**SUBJECT:** NuScale Power, LLC Supplemental Response to NRC Request for Additional Information No. 151 (eRAI No. 8974) on the NuScale Design Certification Application

## **Response to Request for Additional Information Docket No. 52-048**

**eRAI No.:** 8974

**NRC Question No.:** 03.08.04-23

**Figure 3.7.2-156: Enveloping ISRS In-Structure Response Spectra of Cases 1, 2, and 3 at the CNV Containment Vessel Skirt of NPM NuScale Power Module 1, Capitola Input**

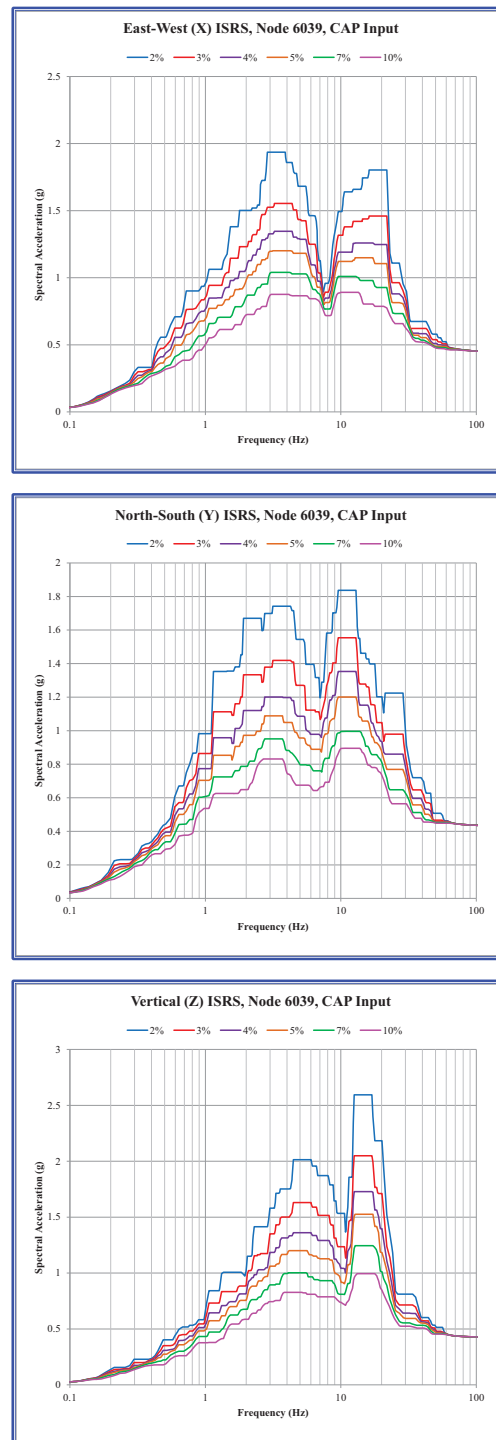
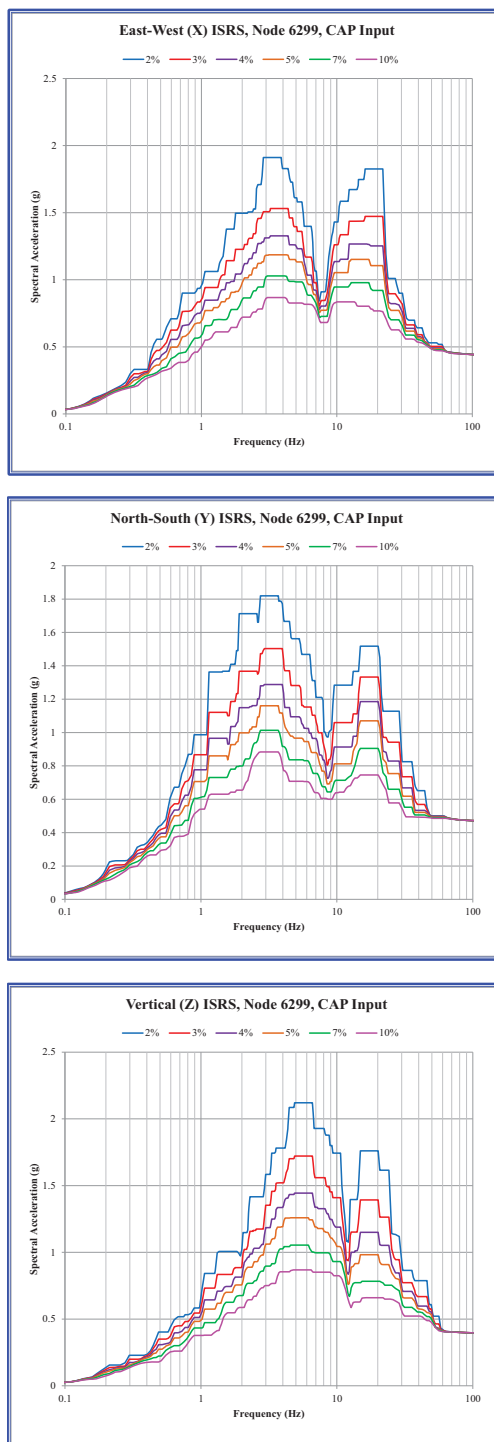
2. **Question:** Clarify if the node numbers in Table 3.7.2-55 are also applicable to the ISRS in Figure 3.7.2-116. If not, please provide FSAR markups to identify the nodes and respective location (e.g. tables and or figures) for the ISRS in 3.7.2-116. Further, please provide the coordinates and or figures showing the location for the nodes listed in Tables 3.7.2-54 and 3.7.2-55.

**Response:** Node numbers in Table 3.7.2-55 are not applicable to ISRS in Fig. 3.7.2-116. Figures 3.7.2-115 and 3.7.2-116 are removed from the FSAR as they do not constitute the standard design basis. Design-basis ISRS at the skirt and lug locations of NPM1 and NPM6 are shown in FSAR Figures 3.7.2-156 through 3.7.2-163.

The resulting spider node spectra are then averaged for each module. This results in nine averaged skirt response spectra for each module, based on the three seismic cases provided (Soil Type 7, Capitola time history, cracked concrete nominal stiffness, cracked concrete reduced stiffness, uncracked concrete nominal stiffness), each with three components (X,Y, and Z). The ISRS of the nine averaged skirt response spectra ~~are~~<sup>is</sup> then enveloped for NPM1 and NPM6 in the X, Y, and Z directions. The six resulting enveloping ISRS (two modules x one skirt support x three directions) for the NPM1 and NPM6 CNV skirts are shown in Figure 3.7.2-156 and Figure 3.7.2-157.

**Figure 3.7.2-164: In-Structure Response Spectra at Node 6328 due to X, Y, and Z Inputs of Capitola Excitation for Soil Type 7, Uncracked Condition**

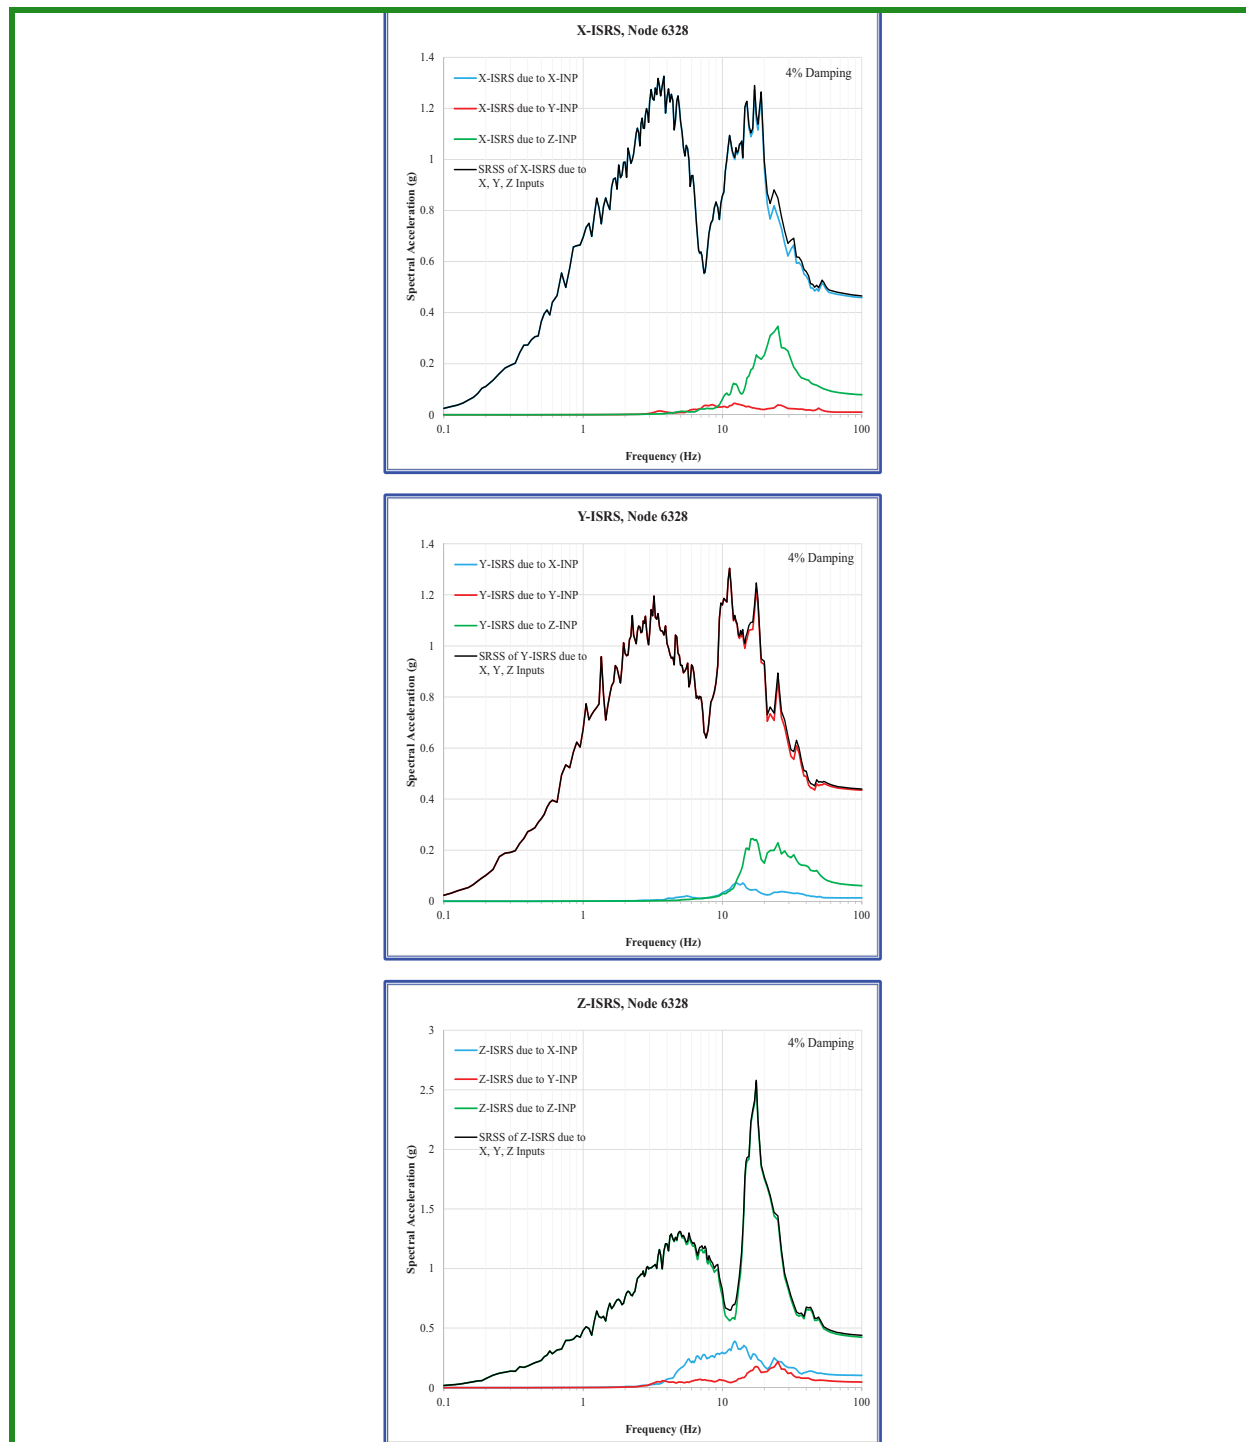
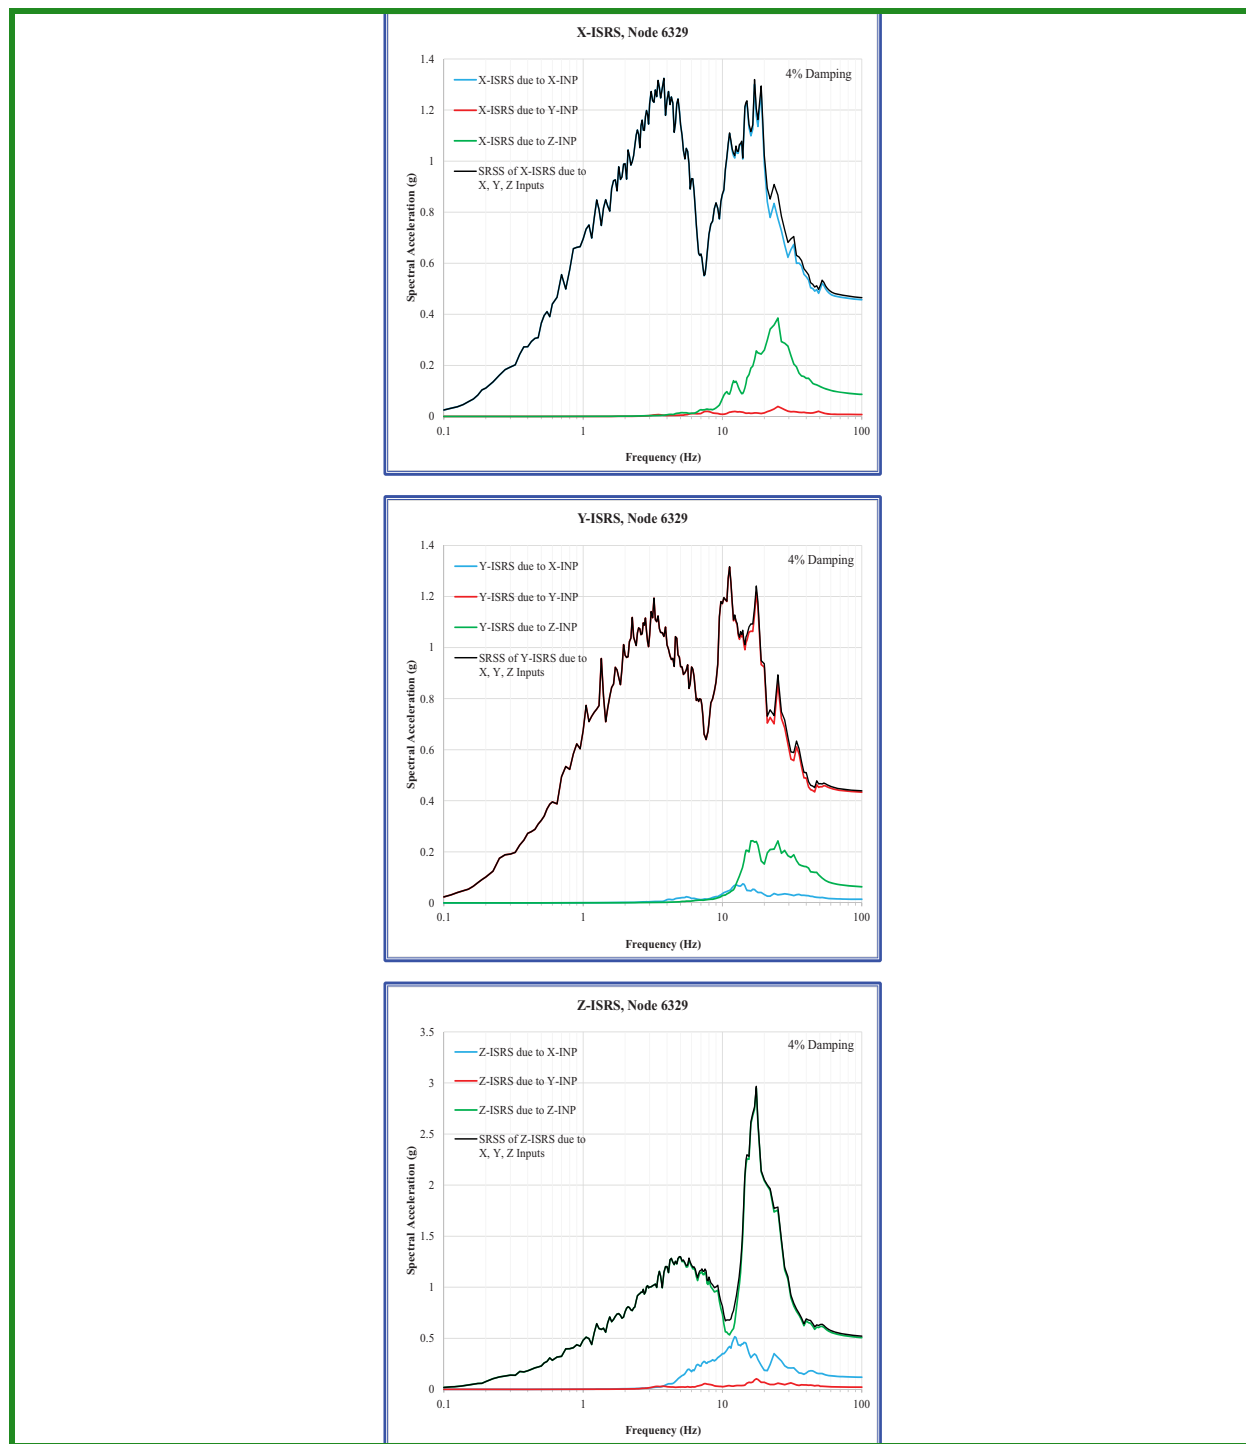
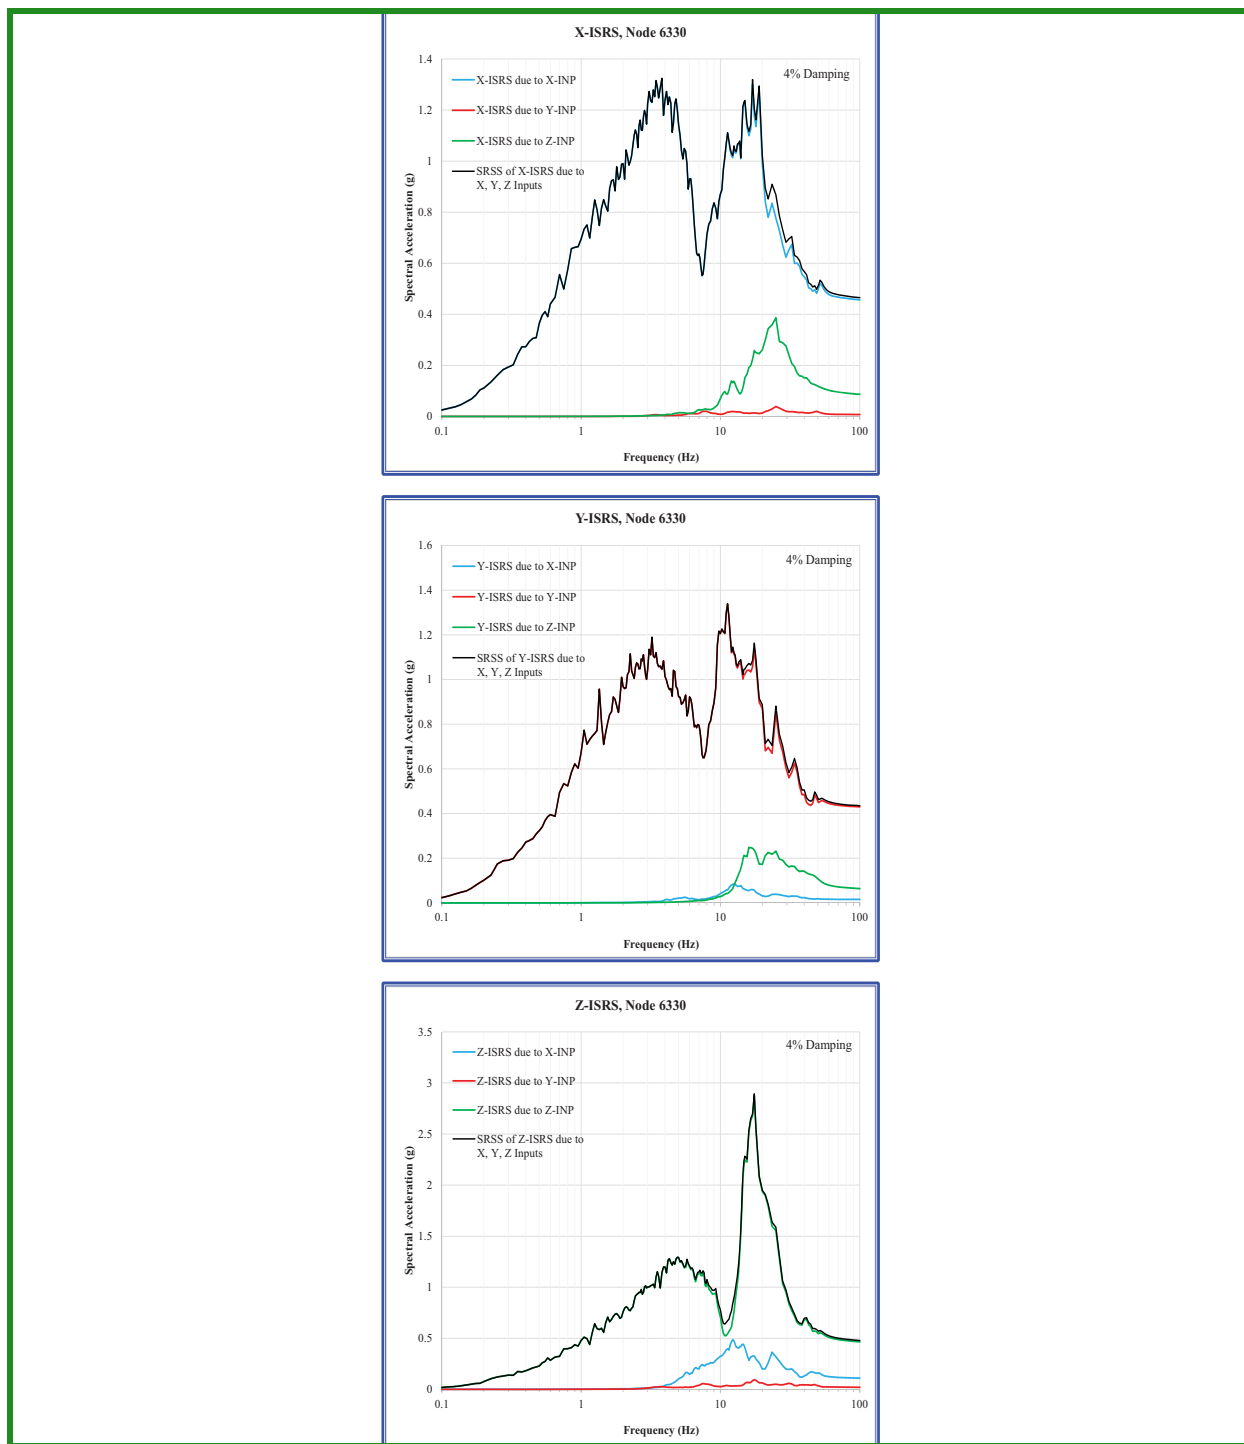
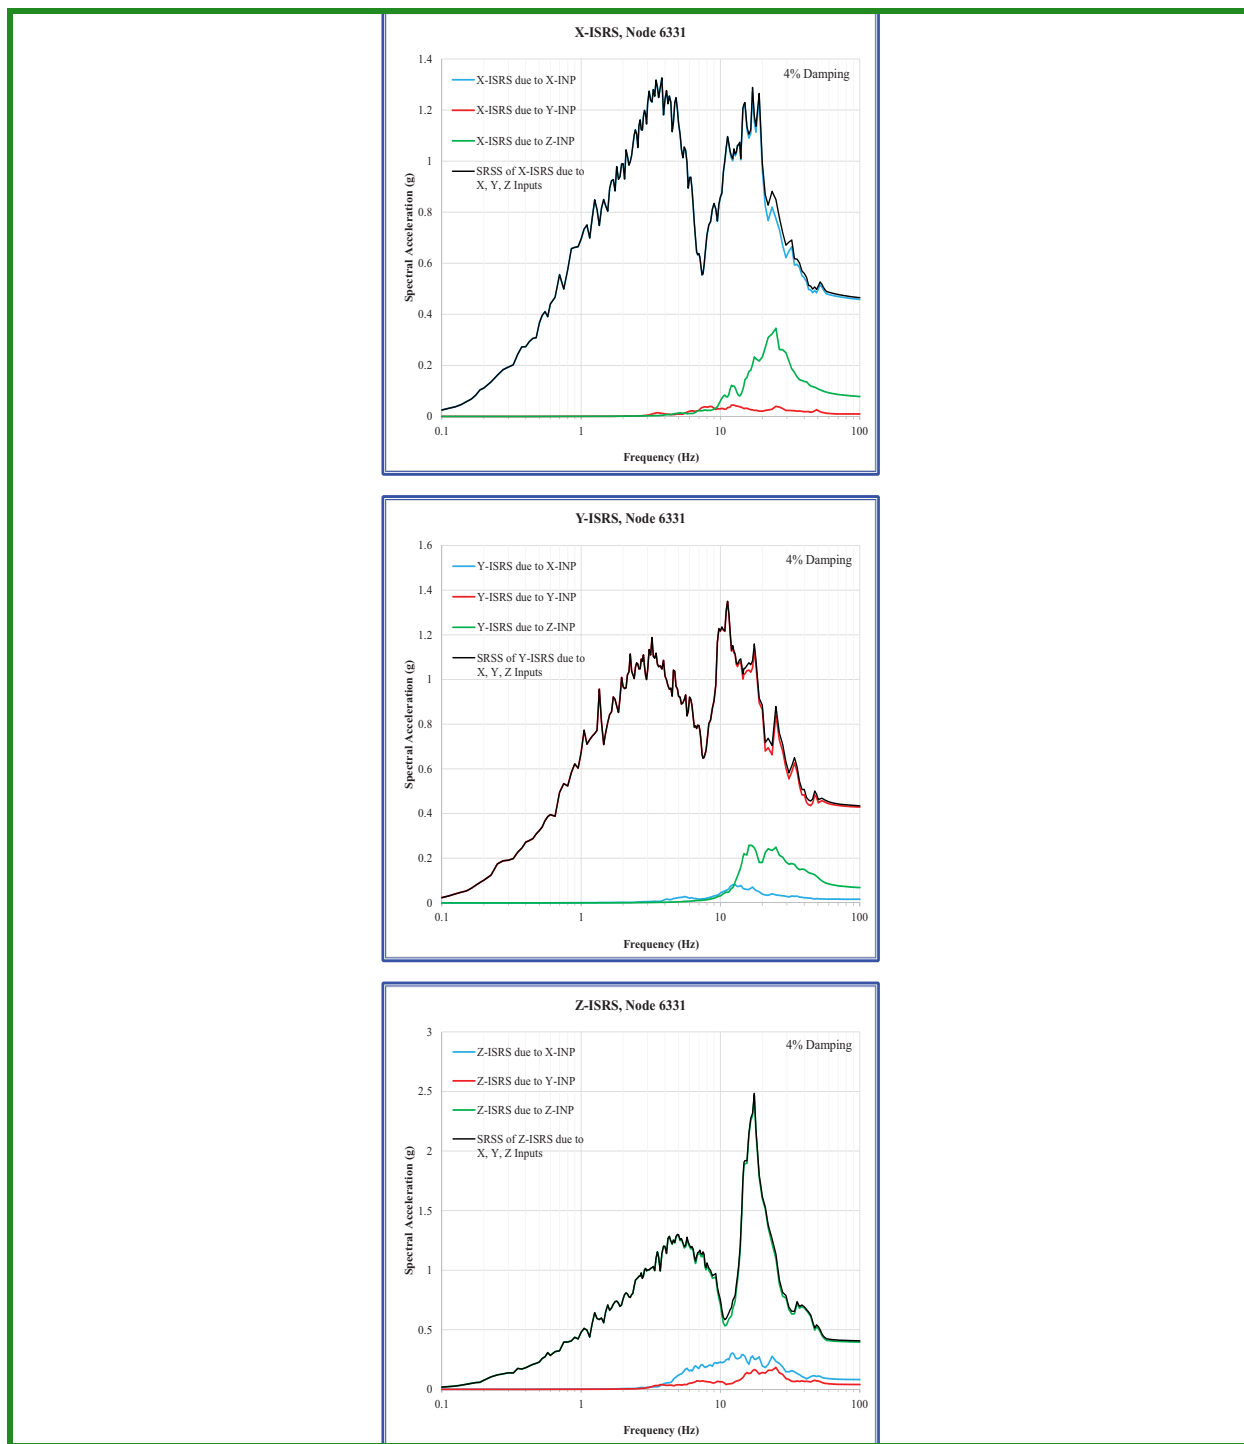
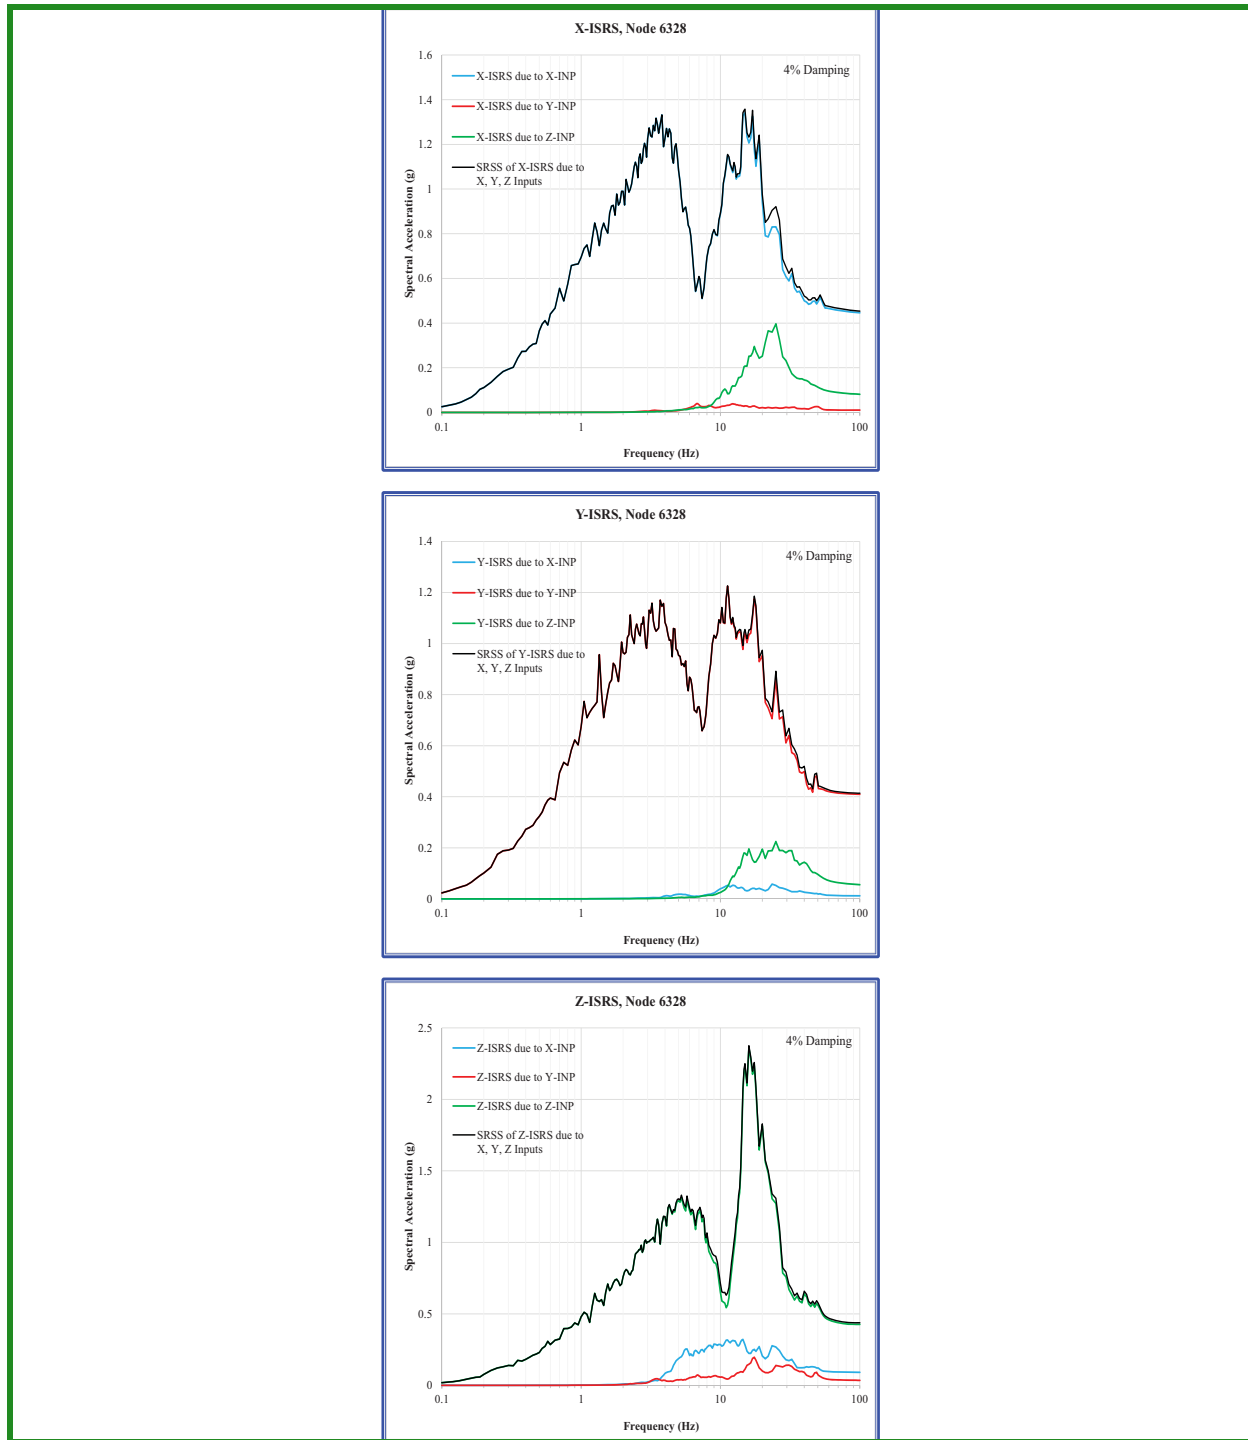
3. **Question:** Additionally, please provide FSAR markups to include an ISRS at the RFT location that is consistent with the input used for the seismic analysis of the lower RPV at the RFT location. Also please, provide markups to identify the nodes and respective location (e.g. tables and or figures)

**Response:** The ISRS at the RFT location are added as FSAR Figures 3.7.2-164 through 3.7.2-171 and the coordinates of the selected RFT nodes are provided in FSAR Table 3.7.2-58, as shown in the attached FSAR mark-up.

Response spectra are generated for time histories at four reactor flange tool (RFT) base locations. The coordinates of these ISRS locations are listed in Table 3.7.2-58. For each case, there are 12 (3 directions x 4 locations) ISRS generated. For the two analysis cases (cracked and uncracked concrete), the total number of ISRS is 24 (12 x 2 cases). The plots of the ISRS are presented in Figure 3.7.2-164 through Figure 3.7.2-171.
